IREDELL COUNTY HEALTH DEPARTMENT

Statesville Office (704) 878-5305 Mooresville Office (704) 660-3625 PERMIT # 205081

IMPROVEMENT PERMIT / AUTHORIZATION TO CONSTRUCT / OPERATION PERMIT / EXISTING SYSTEM

SITE ADDRESS: 110 Honeysuckle Lane Mooresville, NC 28117 PHONE (CPH) 704 361-7717 ALT. PHONE: Bill Duke 248-231-1022

INITIAL SITE SKETCH

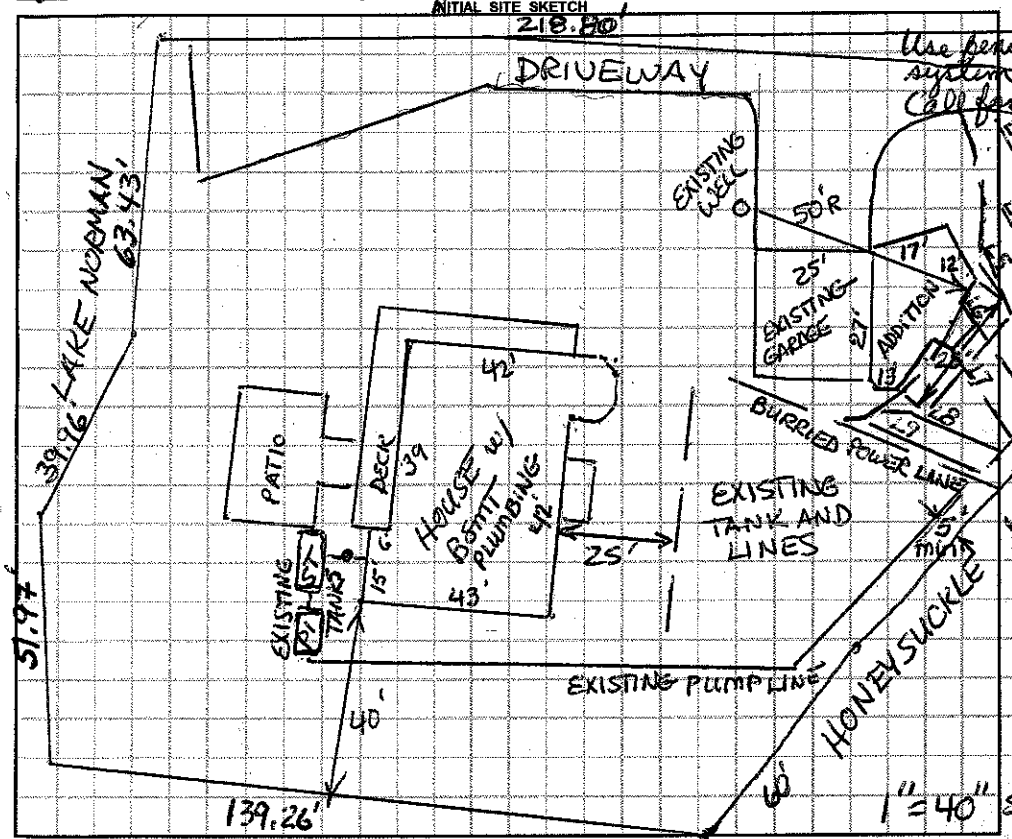
Comments / Conditions: This permit is for existing system pinhead relocation only. No increase above 3BR or 360 gpd max. Drain lines and trench must be at least 5' from foundations. New addition floor must be at 12" or less below surface elevation at closest drain lines. Remove certified operator, maintenance contract prior to operation permit. Replace pump if it can not meet AS BUILT SKETCH pressure requirement of 42.5' 3ft pressure head on each drain line.

Call panel blocks and sand from portions of L4-L7 and replace w/ tamped clay compacted. Replace inlets controlling pressure head to each drain line. (Only use valves in one box by highest line) System will require a

Use fencing to protect septic system during addition construction. Call for onsite pre-installation meeting to install drain lines before doing addition construction. No irrigation lines over drainfield.

Lines	LINE LENGTH	NEW/EXIST
L1	27'	New
L2	38'	Exist
L3	50'	Exist
L4	37'	exist (remove 7'-11')
L5	30'	exist (remove 9'-13')
L6	27'	exist (remove 7'-11')
L7	25'	exist (remove 11'-14')
L8	21'	new
L9	25'	new

L1	27'	6 panels needed
L2	38'	8 panels remaining
L3	50'	12 panels remaining
L4	26'-30'	6-7 panels remaining
L5	17'-21'	4-5 panels remaining
L6	16'-20'	4-5 panels remaining
L7	11'-14'	2-3 panels remaining
L8	21'	5 panels needed
L9	25'	6 panels needed

* must total at least 200'
